SERVICE No. 1008 BULLETIN

Date: September 30, 1997 (M)

Elevator Butt Rib Refinement

PA-31, 31-300, 31-325 Navajo
PA-31-350 Navajo Chieftain
PA-31-350 T1020
PA-31P-350 Mojave

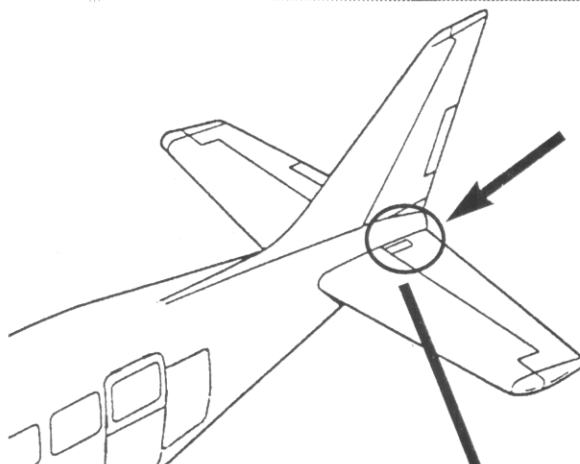
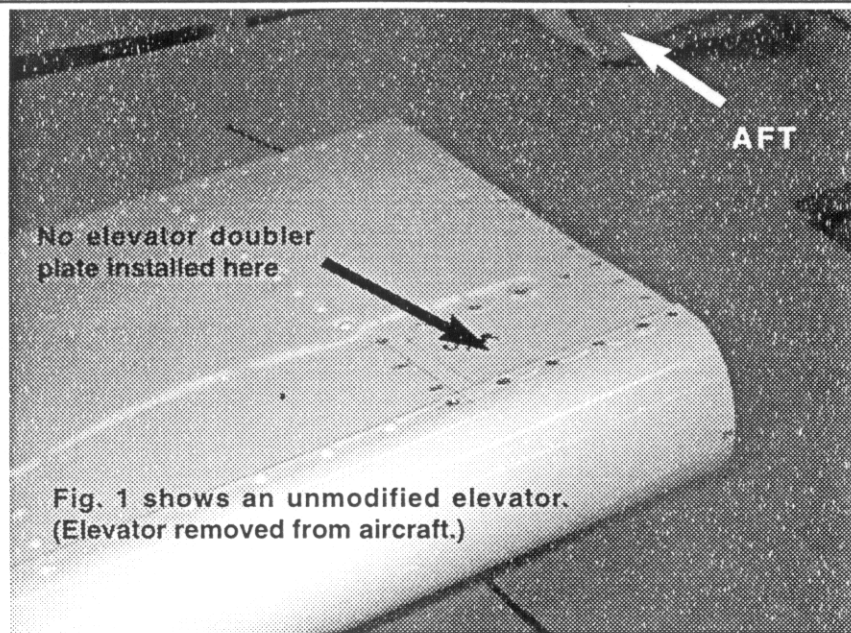
Approximate location of doubler plate on left and right elevators. Installation of doubler plate indicates the installation of the Elevator Butt Rib Refinement Kit p/n 766-642.

3. Install the Elevator Butt Rib Refinement Kit (1 per aircraft), Piper Part Number 766-642. All of the necessary instructions for installation are contained in the Elevator Butt Rib Refinement Kit.
4. Make an appropriate logbook entry of compliance with this Service Bulletin.
